### **Council File Number 15-0317-- Case No. BF 140090 Appeal for 3923-3941 North Hopevale Drive**

Re: Council File No. 15-0317 - Case No. BF 140090  
3923 – 3941 Hopevale Drive – Haul Route Appeal

### **GRADING QUANTITY STUDY FOR 3923 HOPEVALE DRIVE CITY OF LOS ANGELES APRIL 10, 2015**

# EXHIBIT A

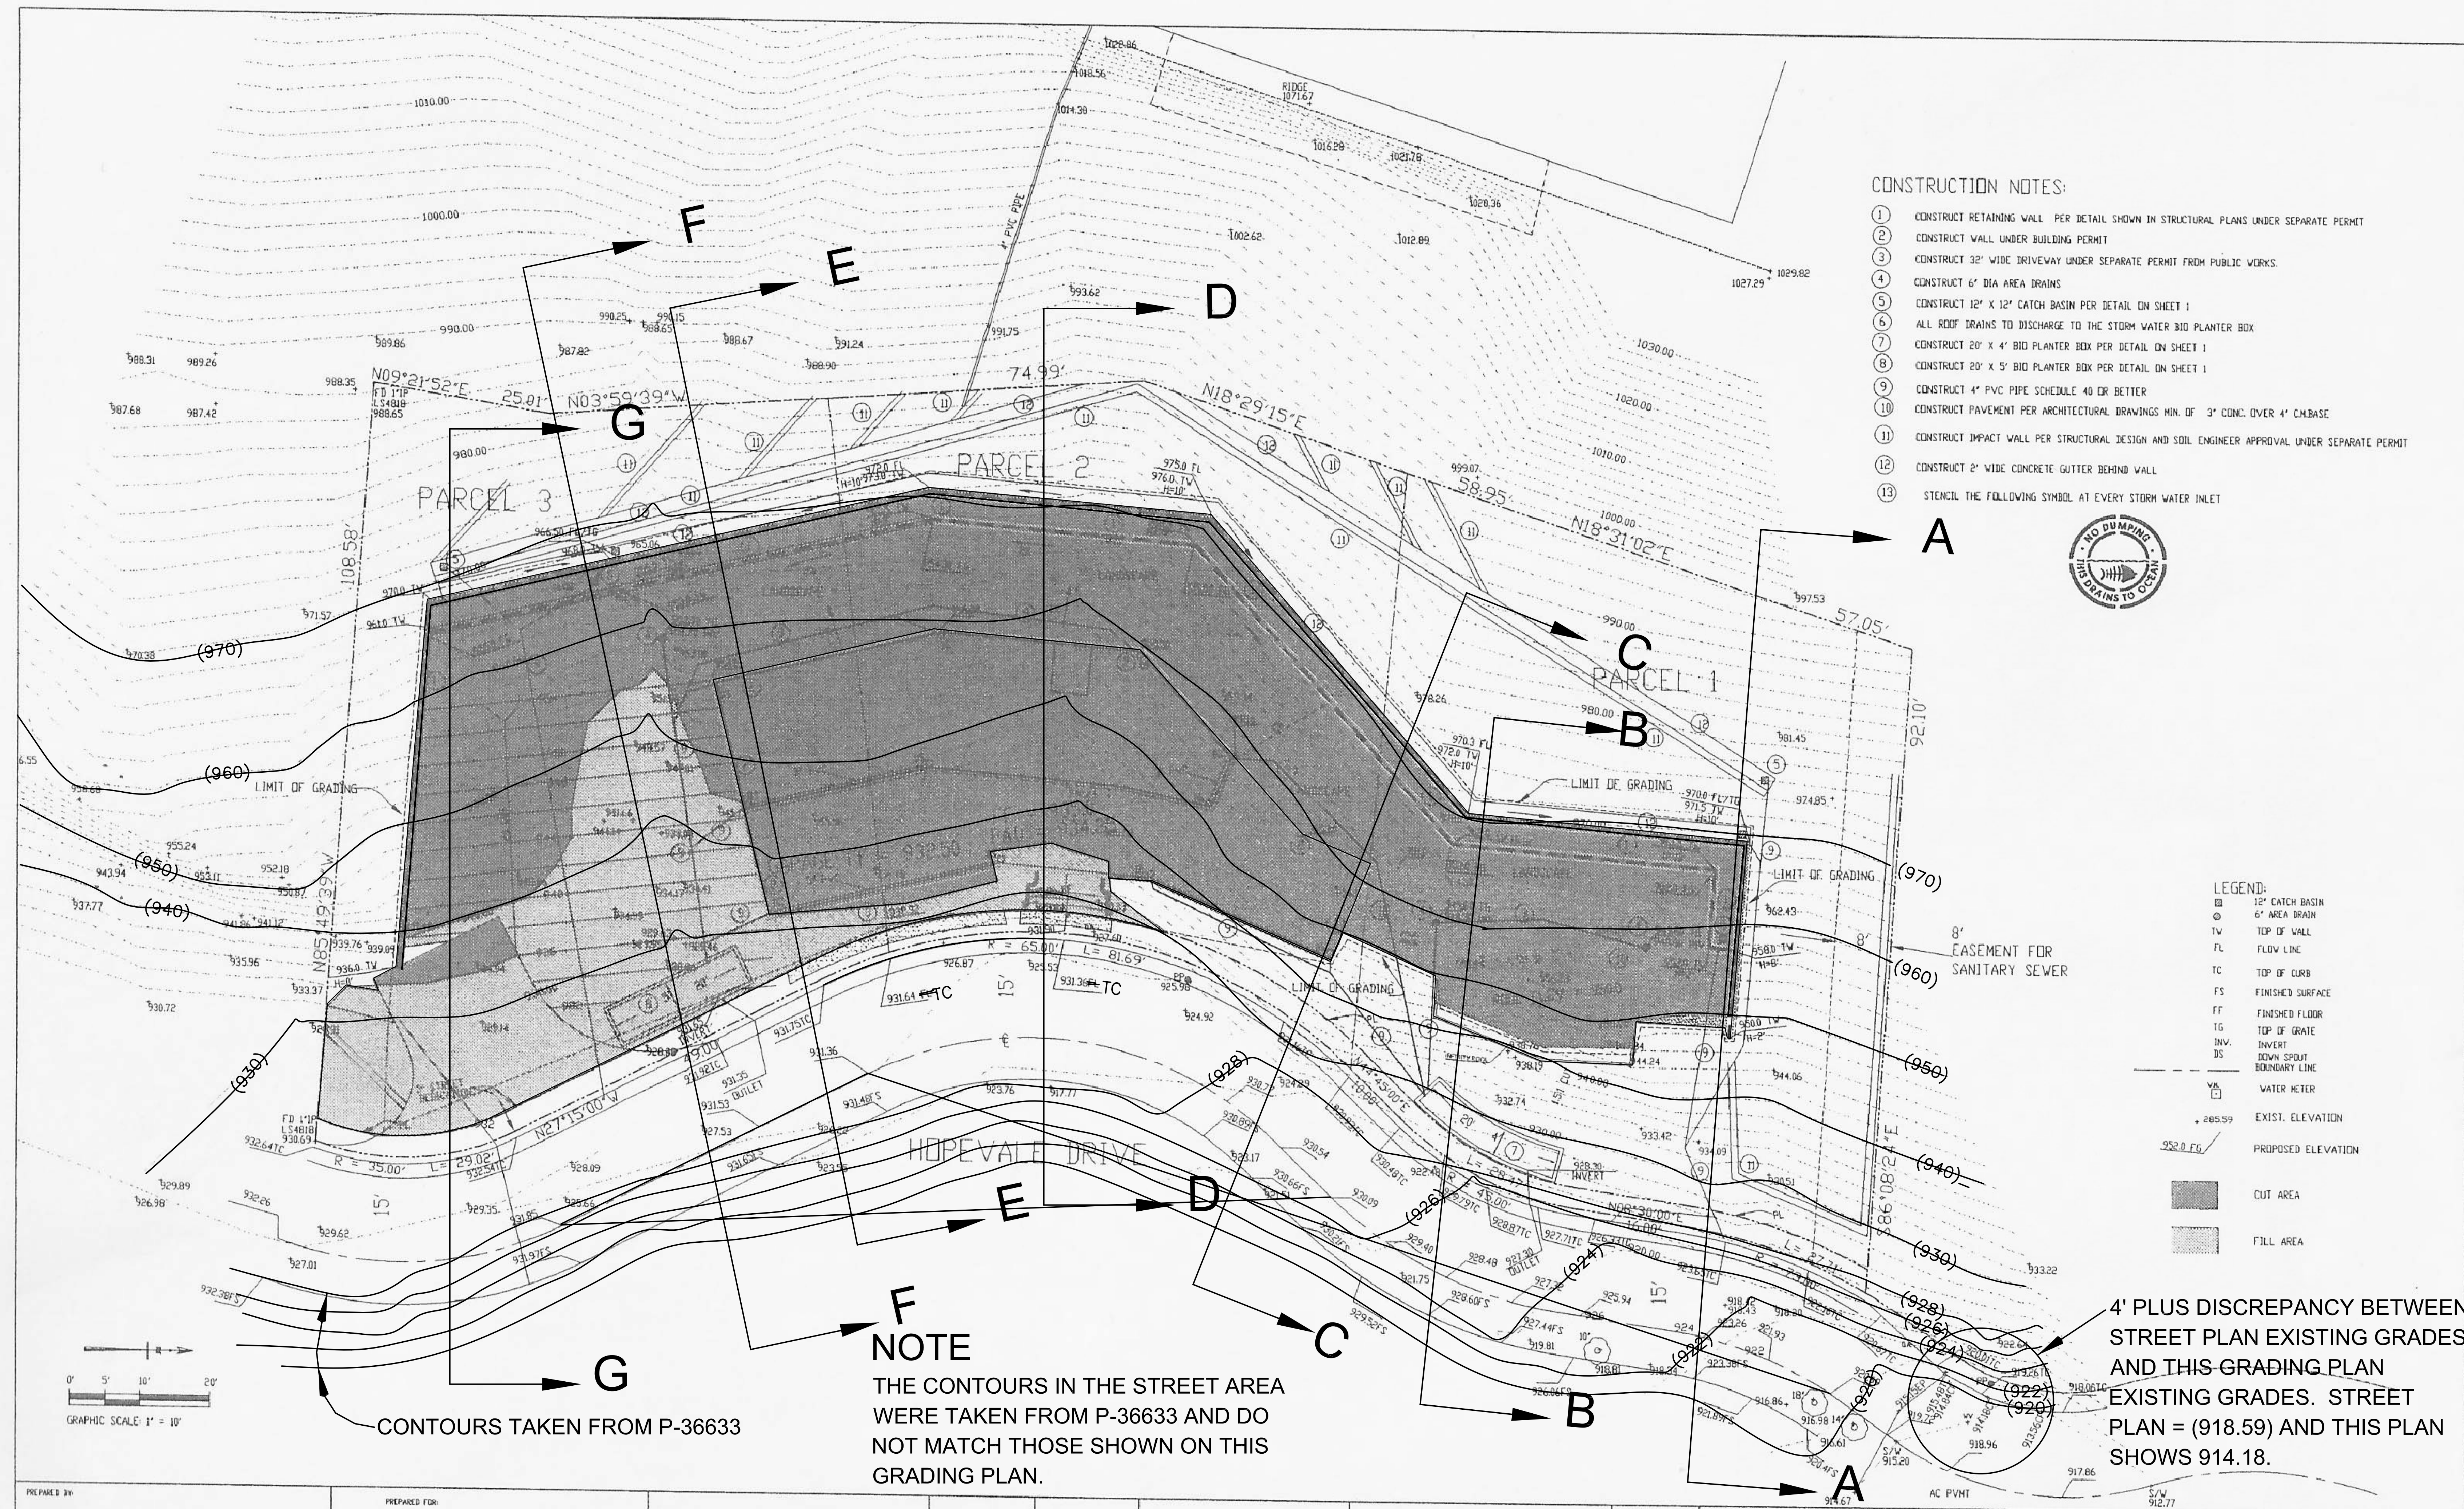
**NOTE**  
 THE CONTOURS IN THE STREET AREA WERE TAKEN FROM P-36633 AND DO NOT MATCH THOSE SHOWN ON THIS GRADING PLAN.

4' PLUS DISCREPANCY BETWEEN STREET PLAN EXISTING GRADES AND THIS GRADING PLAN EXISTING GRADES. STREET PLAN = (918.59) AND THIS PLAN SHOWS 914.18.
